Date 25/03/2020
To Steve Ryan (Tactical Group)
From Ketan Patel (Arcadis)
Copy to Steve Ryan (Tactical Group), Jamie Crawford (Arcadis), Westley Owers (Arcadis)
Subject MPE Stage 1 UDLP v11 – DPIE Response

Table 1 Response to DPIE comments

Landscaping on the western batter of the IMEX terminal site *[and eastern batter]*

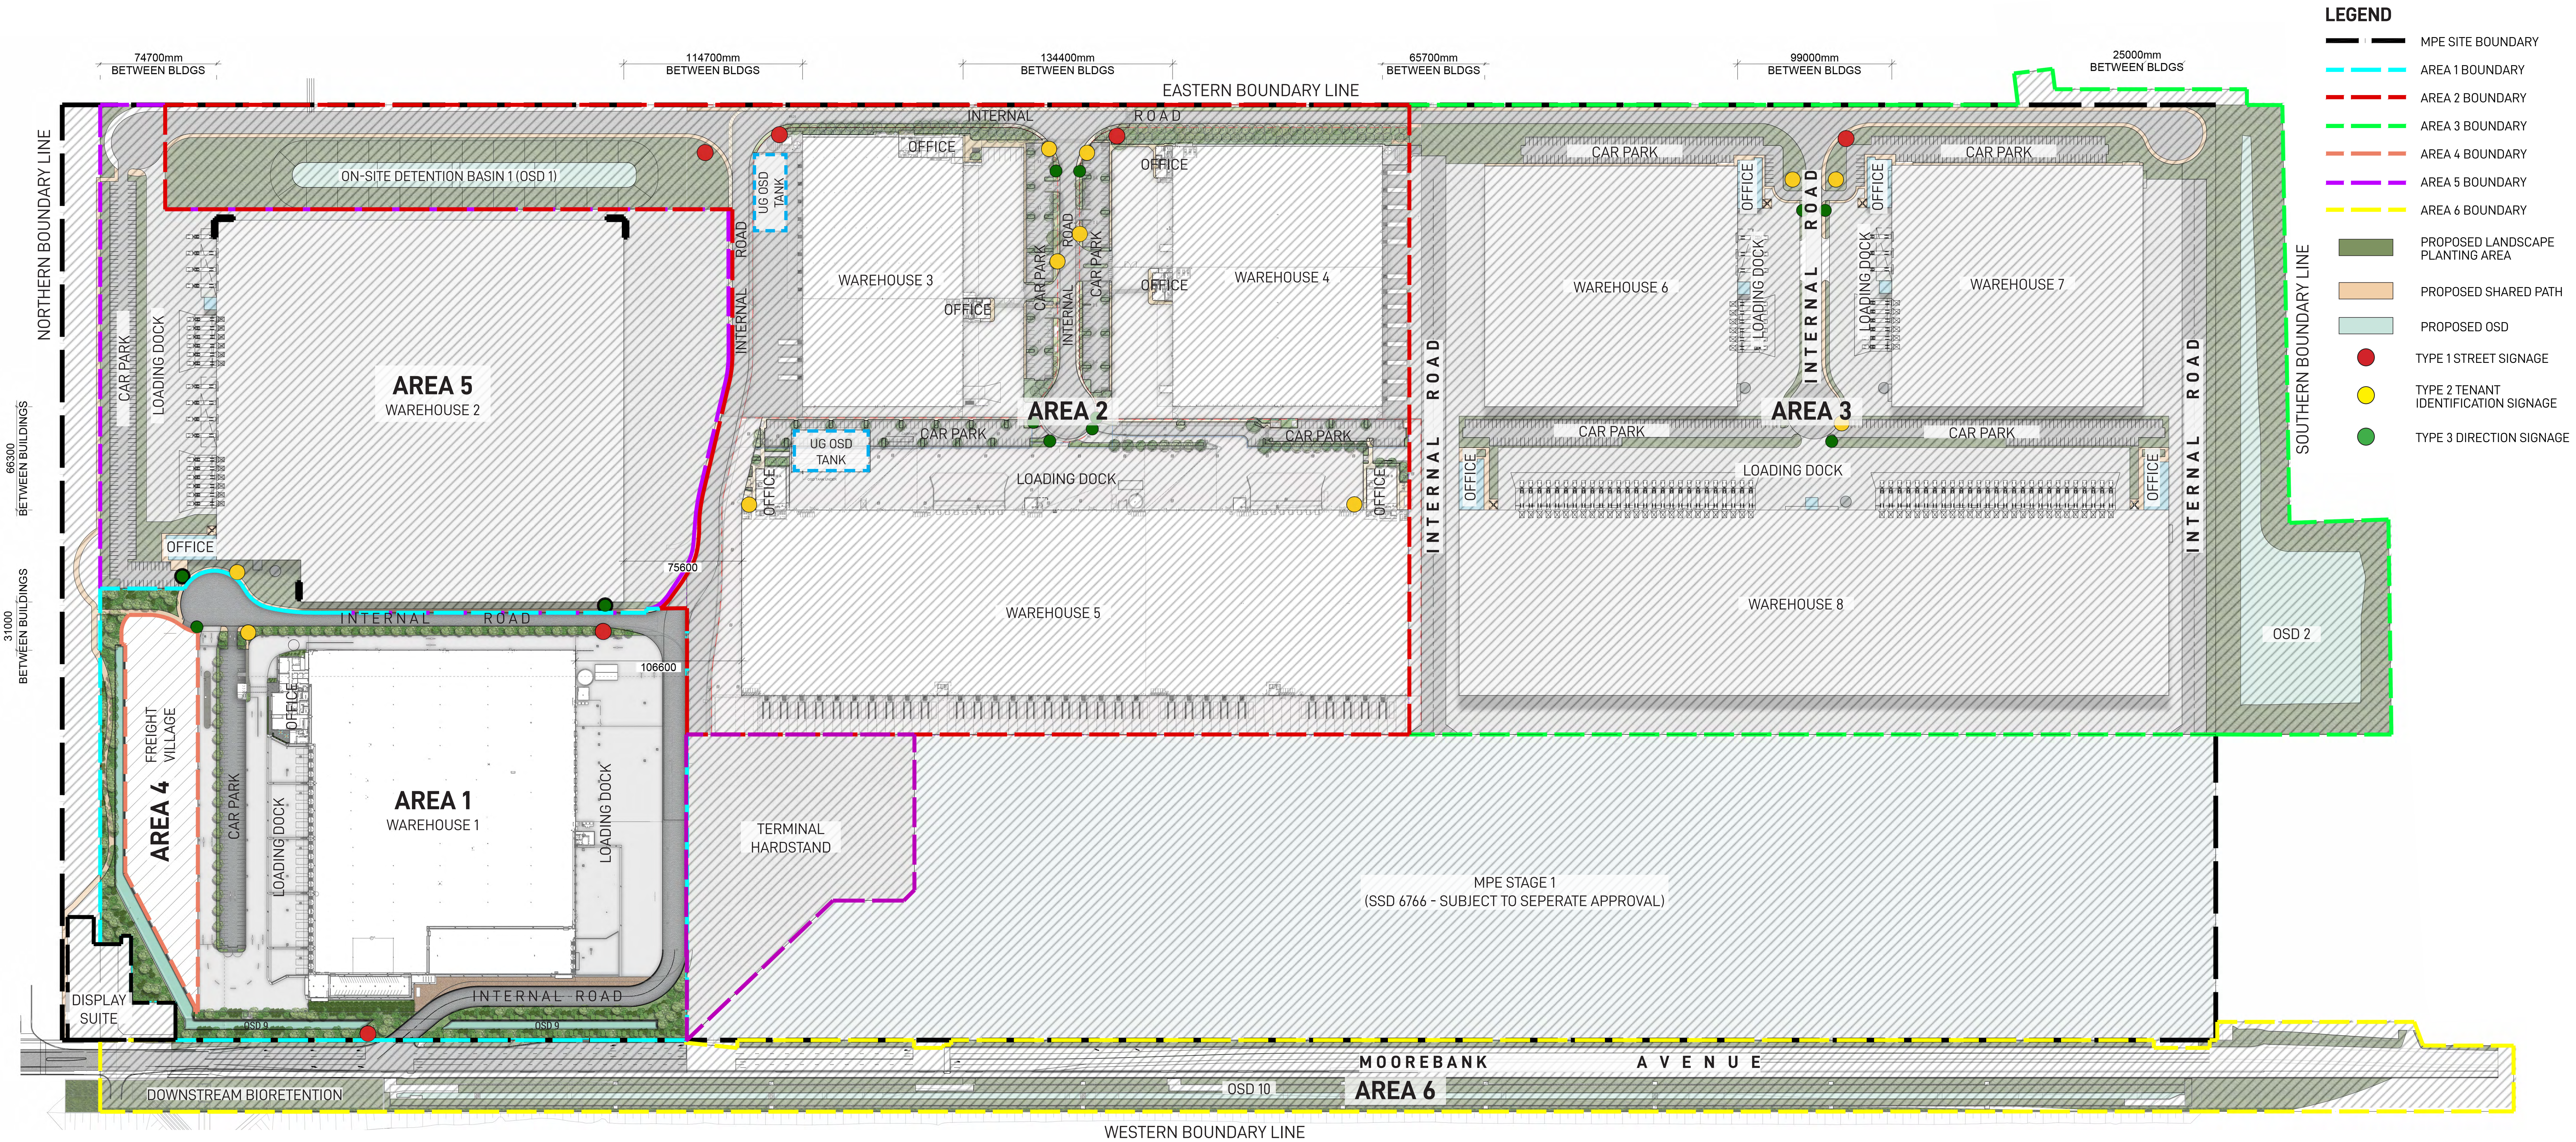
To assist the Department in its review I request that you undertake the following:

carefully review the proposed landscape design of the IMEX terminal site against the approved plans and documents to ensure that there is no net loss of landscaped areas;	The removal of the Eastern Batter swale would result in a loss of 19,094m² of landscaping within the IMEX. However, the Project has projected the landscaping cover across the MPE Site and submitted calculations demonstrating this as part of the MPE Stage 2 Area 2 UDLP submission, particularly Appendix H1 and Appendix G. See below.	MPE Landscape Masterplan MPE Development Layout Plan
provide alternative outcomes, such as compensatory landscaping on	Alternative outcomes have been investigated; the preferred option being to compensate the loss of landscaping on the eastern bioswale by providing additional landscaping within the MPE Stage 2 site. It is not possible to retain any if the eastern bioswale landscaping as the entire eastern bioswale is being raised flush with the IMEX and MPE Stage 2 to provide hardstand access between MPE Stage 2	MPE Landscape Masterplan

Attachment A – MPE Landscape Masterplan

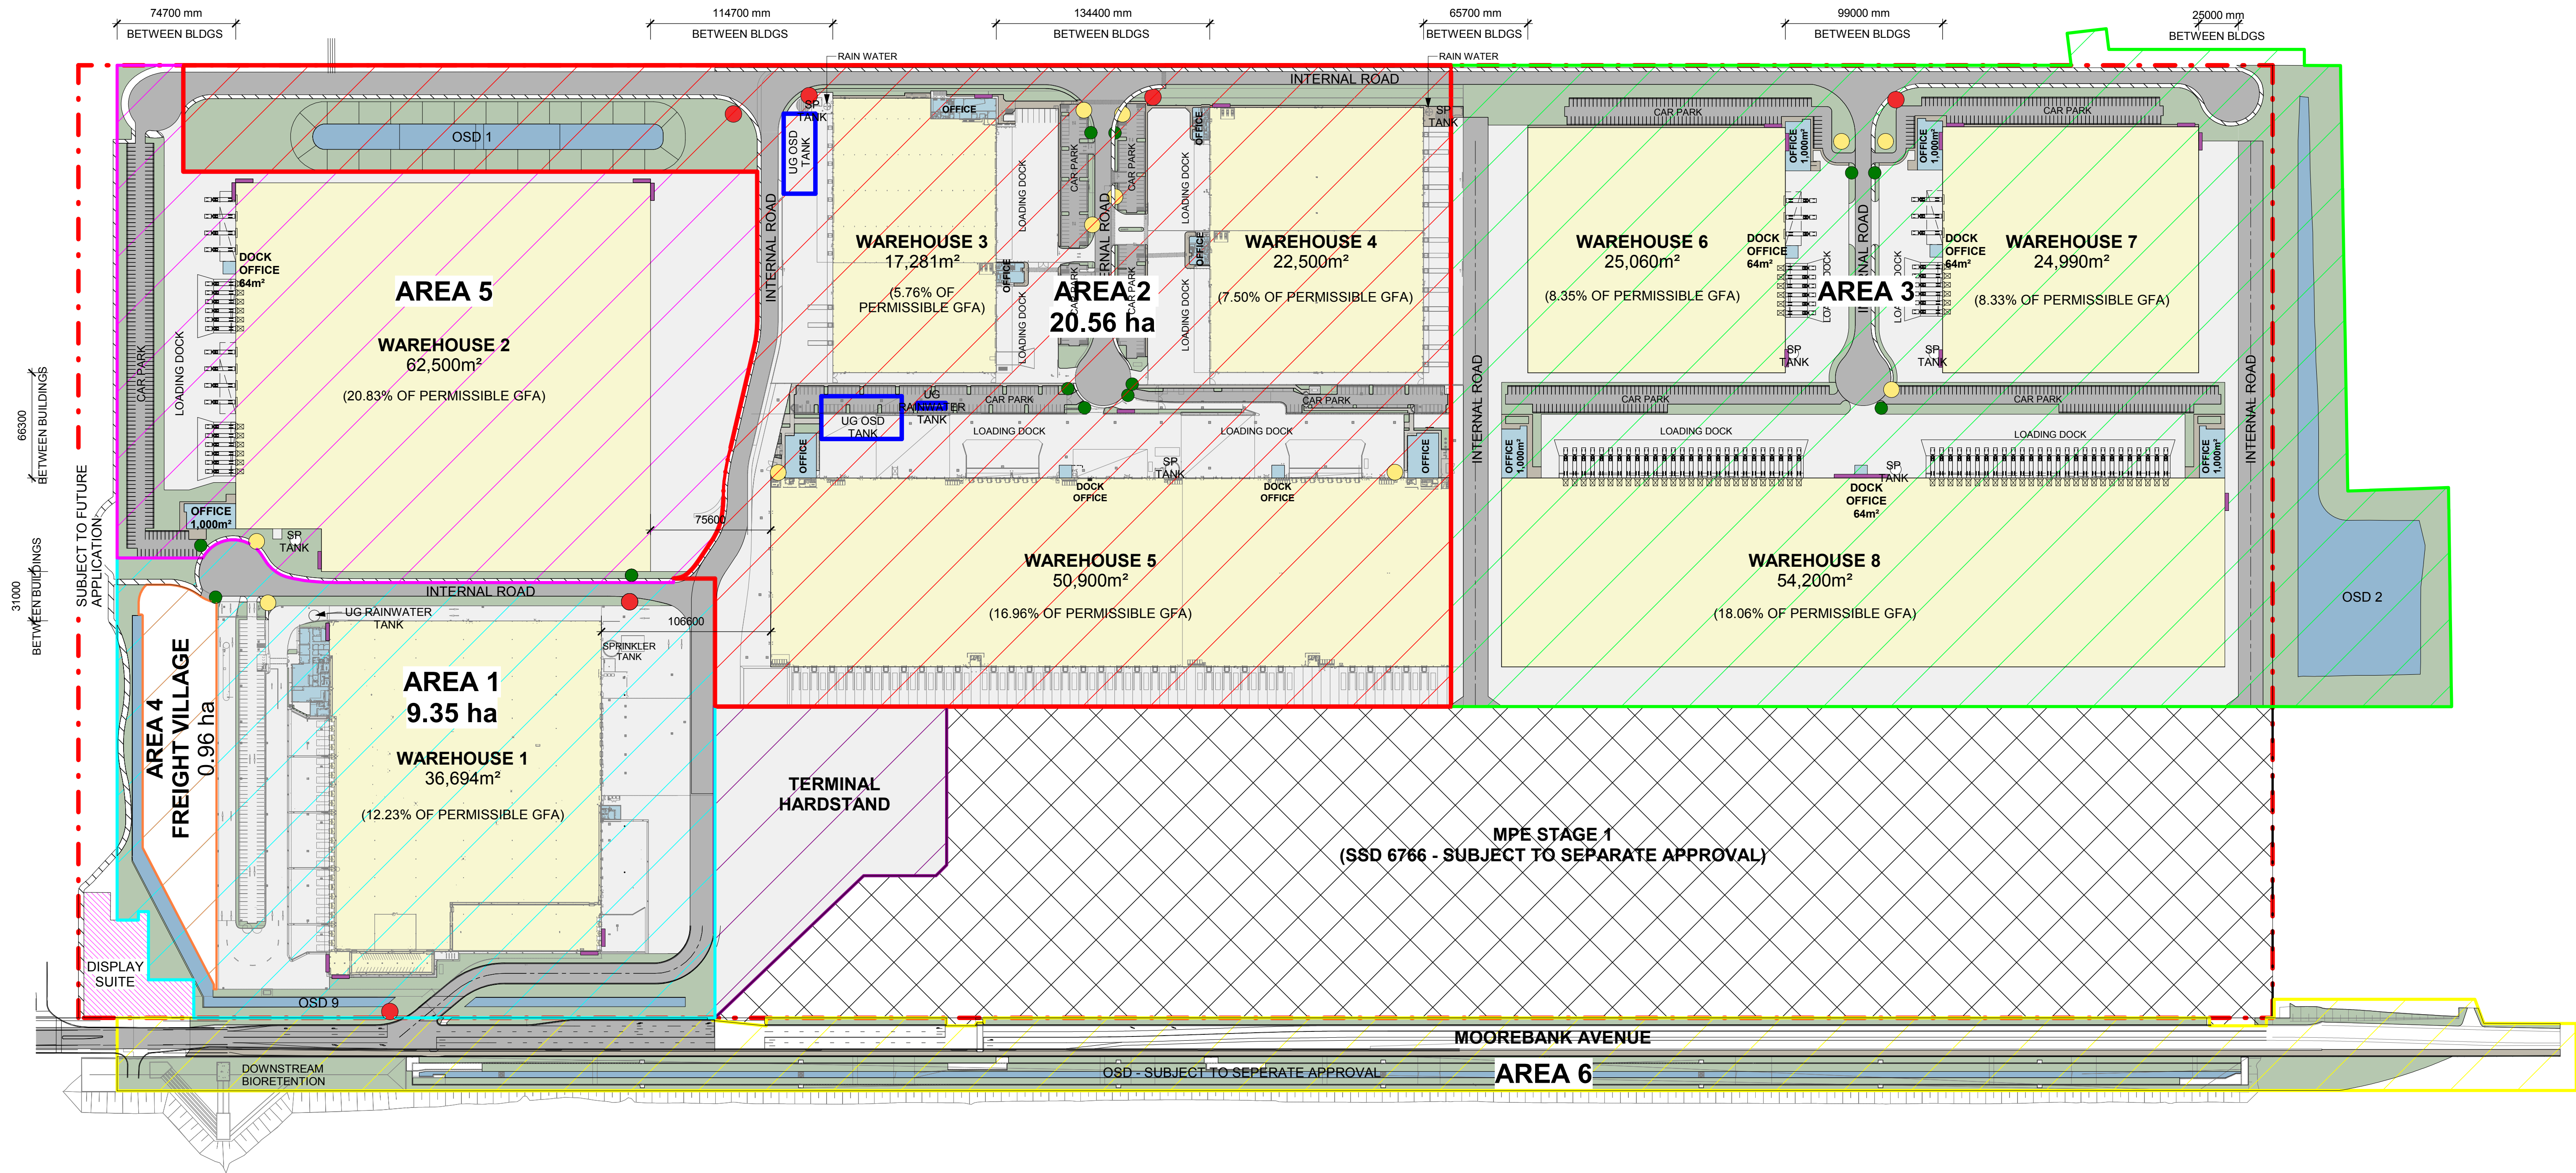
submit an updated landscaping plan for the IMEX site; and	The IMEX landscape plan was previously submitted within the UDLP V11. Please find attached the current MPE Landscape Masterplan and Development Layout Plans for information (Attachments A and B respectively).	MPE Landscape Masterplan MPE Development Layout Plan
submit an updated Landscape Master Plan for the MPE site.	Please find attached the current MPE Landscape Masterplan and Development Layout Plans (Attachments A and B respectively) for information which reflect current percentage cover relating to landscaping coverage across respective areas of the MPE site including the compensatory landscaping for loss of the IMEX eastern bioswale.	MPE Landscape Masterplan MPE Development Layout Plan
